Addendum to BIA Submission

55 Fitzroy Park
Camden
N6 6JA

LBH4480biaa Ver. 1.1

Following an audit of the submission by Campbell Reith Hill (CRH), dated 23rd November 2018, this document has been prepared to address the issues raised and to provide the additional information requested.

Camden 1920 Geological Map (Figure 2, CGHHS, 2010)
(London Clay is shown to underlie the site)

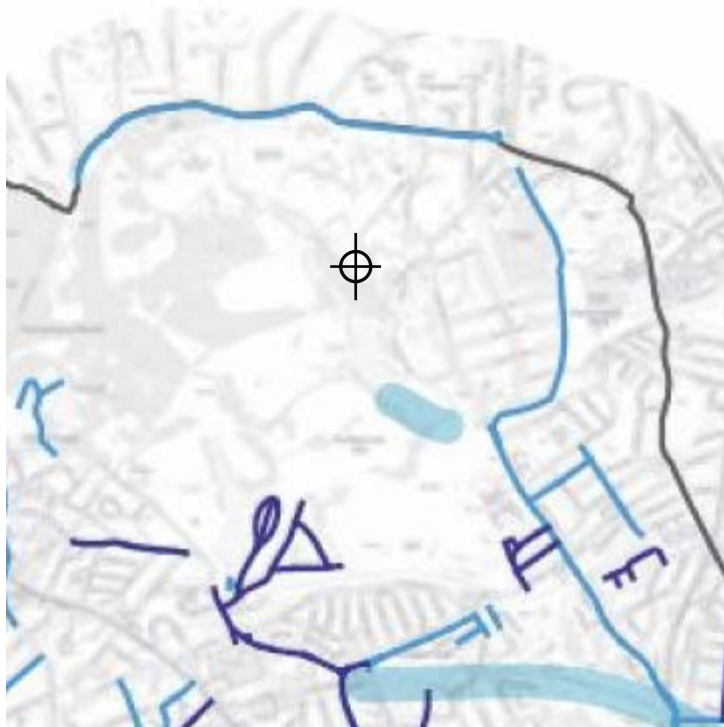
<p>Does the description of the proposed development include all aspects of temporary and permanent works which might impact upon geology, hydrogeology and hydrology?</p>	<p>No</p>	<p>The construction of an embankment next to the pond to facilitate the incorporation of access paths requires further description. Refer to section 4 of this audit report.</p> <p>The impact of the numerous changes proposed to the surface water drainage system on the existing pipe network needs further assessment.</p>	<p>The embankment construction is further described in this document. (section 2.4)</p> <p>The BIA is concerned with any potential impacts upon geology, hydrogeology and hydrology.</p> <p>An addendum surface water drainage statement accompanies this report.</p>
<p>Are suitable plan/maps included?</p>	<p>No</p>	<p>Relevant Arup GSD map extracts have not been included.</p>	<p>Map extracts are included in this document. (section 2.1)</p>

The relevant Map extracts from the Camden Geological, Hydrogeological and Hydrological Study are presented below.

2.3 Groundwater Monitoring

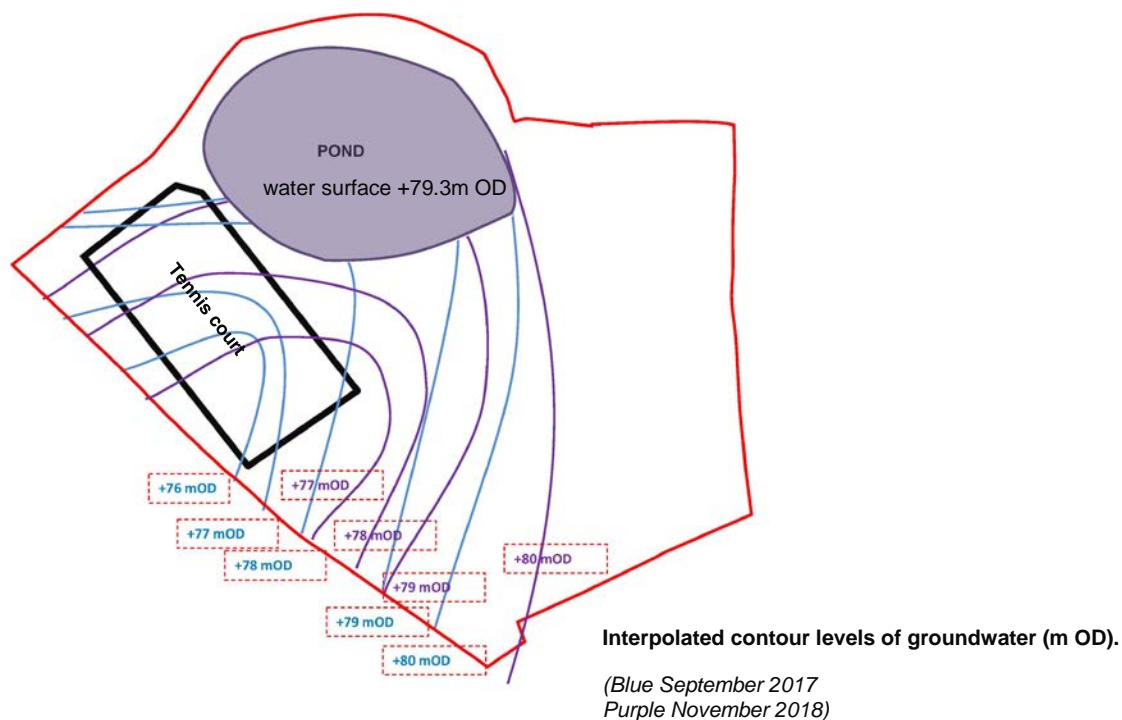
Audit Query No.	CRH Query	LBH Response / Action	Status
1	Groundwater monitoring data has to be provided.	Groundwater monitoring data is now provided. (section 2.3)	Addressed
2	Require outline design of temporary and permanent retaining walls to assess their suitability.	Outline design of the retaining walls are now provided. (appended)	Addressed
3	Assessment or calculations showing the overall difference in the inflow and outflow with respect to the site, before and after construction has to be presented.	An addendum surface water drainage statement accompanies this report.	Addressed
4	A detailed utility survey for the area is required, along with details regarding the existing drainage pipe running underneath Millfield Lane.	See attached. No drainage pipe is believed to be present underneath Millfield Lane.	Addressed
5	The slope stability analysis of the design of the MSE wall is required to confirm the stability of the embankments constructed south of the man-made pond.	The embankment construction is further described in this document. (section 2.4)	Addressed

The results of the groundwater monitoring are presented below:

The monitoring data suggests the configuration of the water table is consistent with the assertion that groundwater is flowing across the impermeable surface of the London Clay, as shown on the plan below.
